Product change information

PCN no.:	ACM130015	Date:	11/21/2016
----------	-----------	-------	------------

DNV-GL and ABS approval granted, remote shutdown and Modbus configuration added

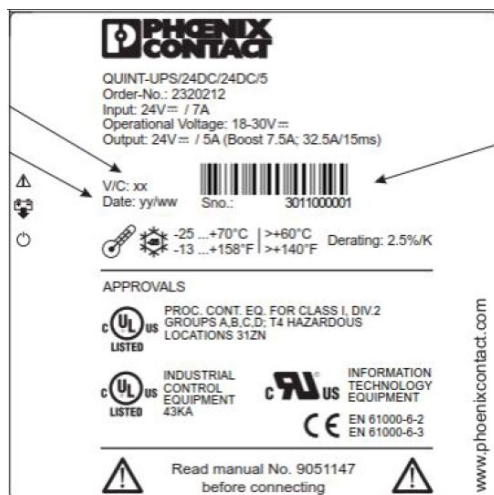
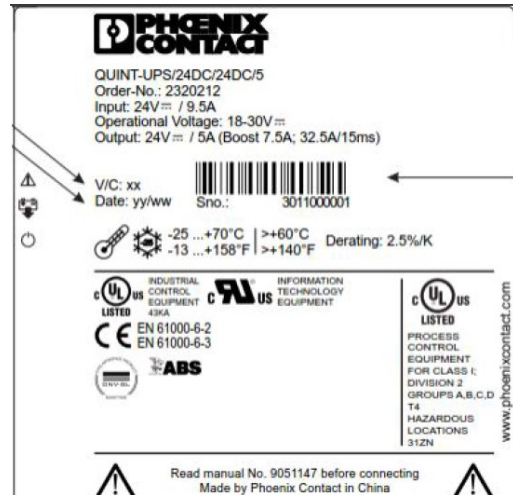
- 1.) DNV-GL and ABS: approvals are granted.
- 2.) Remote shutdown: R2 activation is indicated by a green flashing LED (POWER IN OK). PC mode includes PC shutdown per remote control. Temporary and permanent operating modes are unchanged.
- 3.) Modbus configuration: Modbus address and baud rate are adjustable. Configuration up to V/C:04 cannot be applied from a stick or file. V/C:06 devices are supported by UPS-CONF as of v2.2.7.3.
